PLANNING COMMISSION REPORT
Regular Agenda -Public Hearing Item

**ITEM NO. 1B PRELIMINARY DEVELOPMENT PLAN FOR HERE @ KANSAS; 1101
AND 1115 INDIANA ST (SLD)**

PDP-14-00183: Consider a Preliminary Development Plan for HERE @ Kansas, located at 1101 & 1115 Indiana St. Submitted by Hartshorne Plunkard Architects on behalf of HERE Kansas LLC, Contract purchaser. Berkley Flats Apartments, LLC and Georgia Bell, property owners of record.

Figure 3: Building Height Summary - Approved PDP

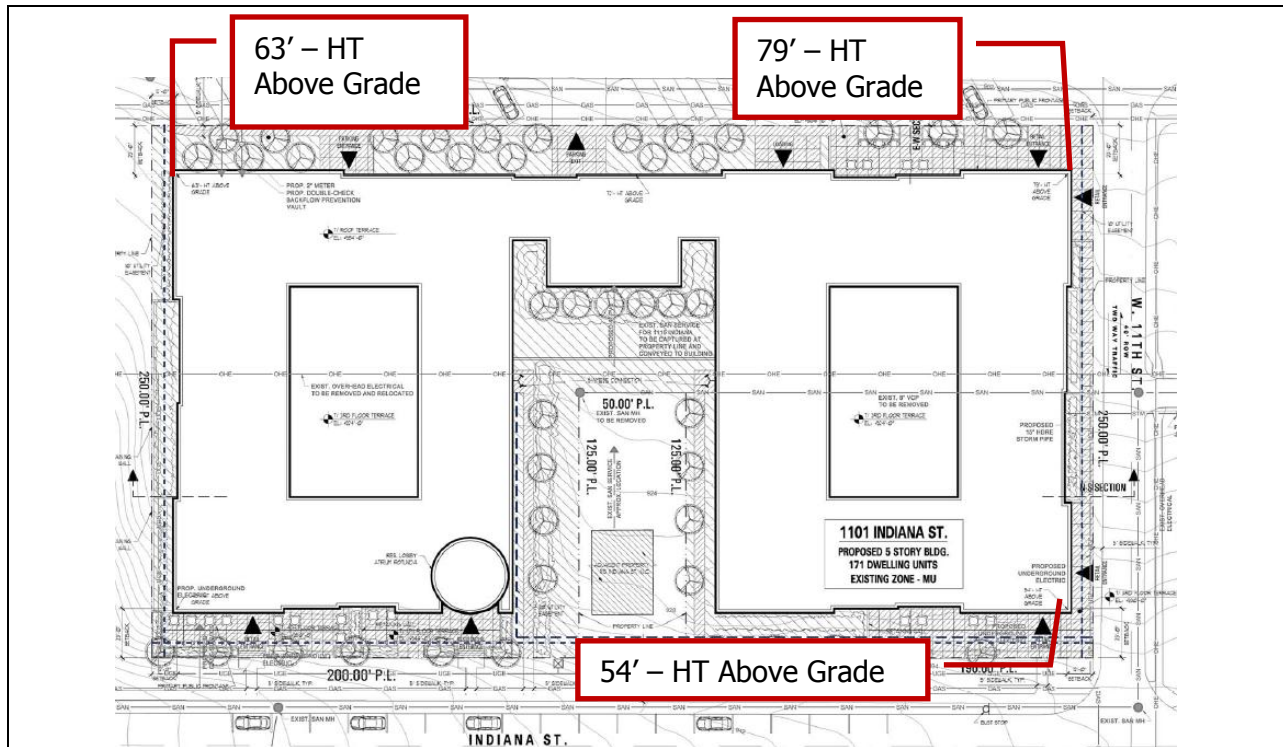
The previous plan included a summary of overall building height at each corner of the development.

Figure 4: Building Height Summary - Proposed PDP

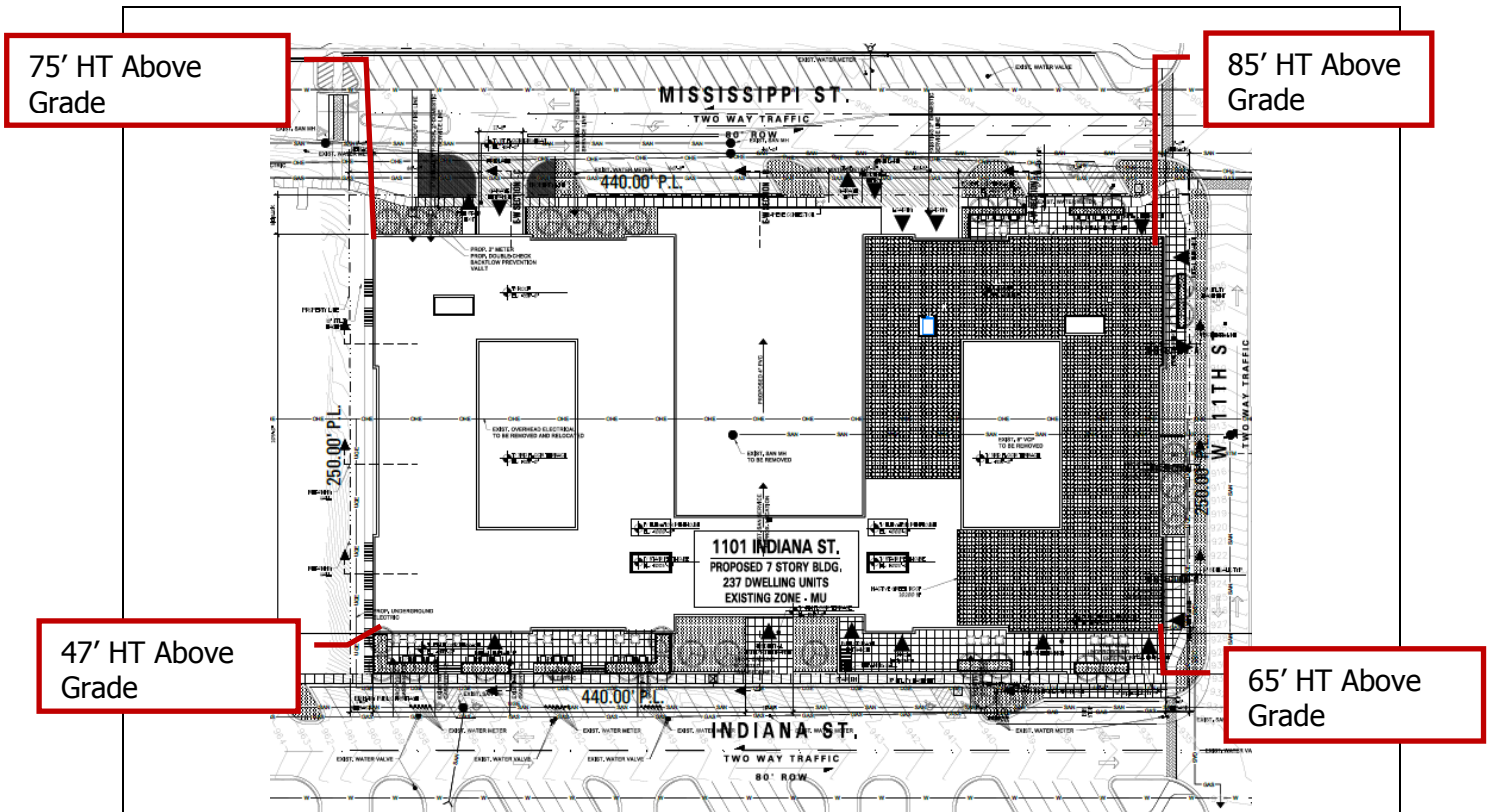
The proposed plan does not include this same data with regard to the maximum height shown on the site plan. Height of the development has been reviewed based on the building elevations included with the site plan (PDP-13 to PDP-16).

The proposed development requires revision to the overall building height or an adjustment to the development credits used to comply with the design standards.

10. Revise the development plan to show a 14' setback required to meet to meet the standard of section 20-701 (g).
11. Revise the development plan to and to show that the building height complies with the maximum 80' allowed per the MU District and proposed redemption of development bonus points.

Figure 6: Angled Parking Exhibit with Parallel Spaces on S. side of Mississippi St.

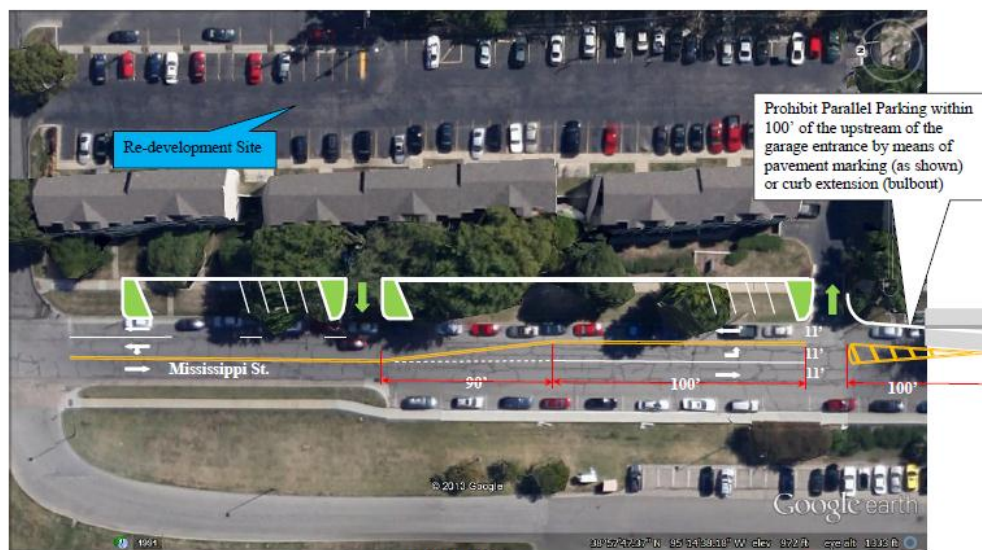
A significant concern expressed by many review agencies is the potential conflict with angled parking and bike/pedestrian activity. This area is one of the highest percent shares of bicycle/pedestrian travel counted in this area. Establishment of safe design is a critical consideration. In order to accommodate all uses within the Mississippi Street corridor, additional right-of-way width may be required.

An additional concern has been the establishment of an adequate bus stop along Indiana Street that meets the demands of City and KU transit systems. The number and frequency of busses, as well as a design that accommodates the street grade, turning radius and other design considerations are factors to be addressed. The final bus stop design may impact the number of on-street parking spaces.

6. Revise Sheet PDP-01 to note property owners of record and indicate Here Kansas, LLC as developer.
7. Revise drawing set to include the angled parking exhibit. The on-street parking design is conceptual with the Preliminary Development Plan approval and may require modification with the Final Development Plan pre review comments of staff and the University of Kansas.

PDP-01

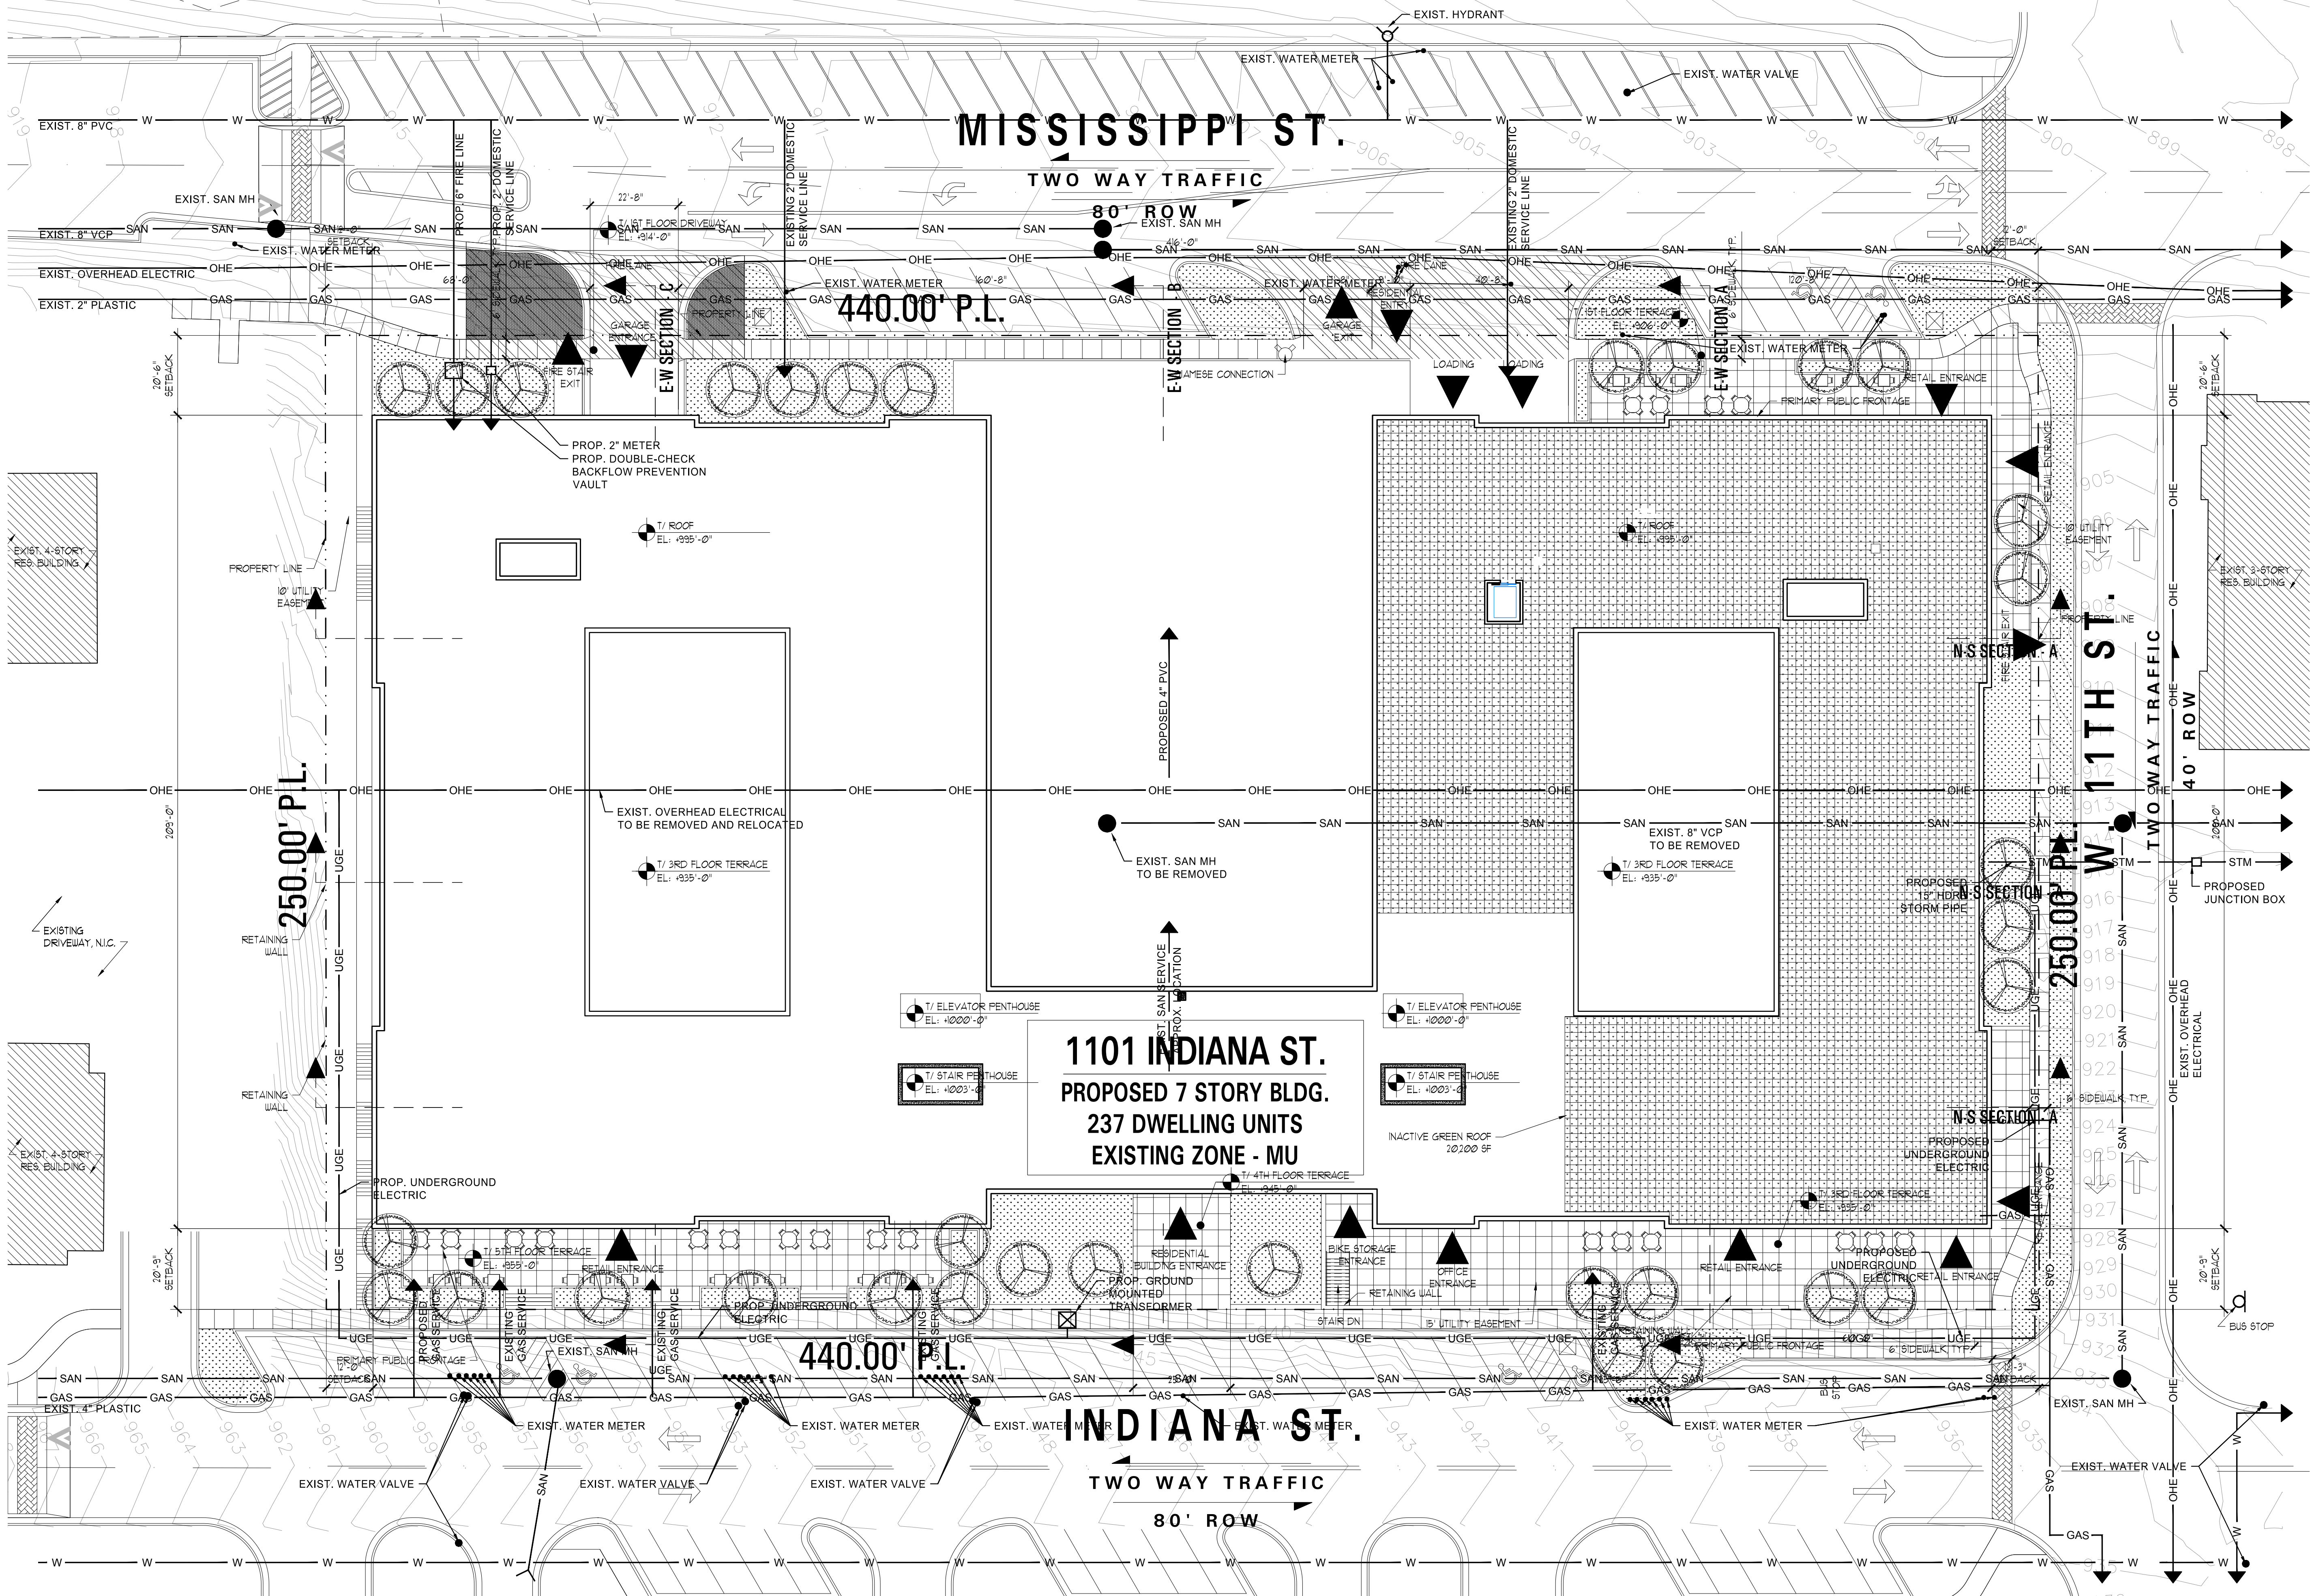
8. Revise the Project Data Summary on sheet PDP-01 to show 172 units on face of plan not 173.
9. Revise the Project Data Summary on sheet PDP-01 to show required parking consistent with the MU-PD Development Bonus Utilization Summary.
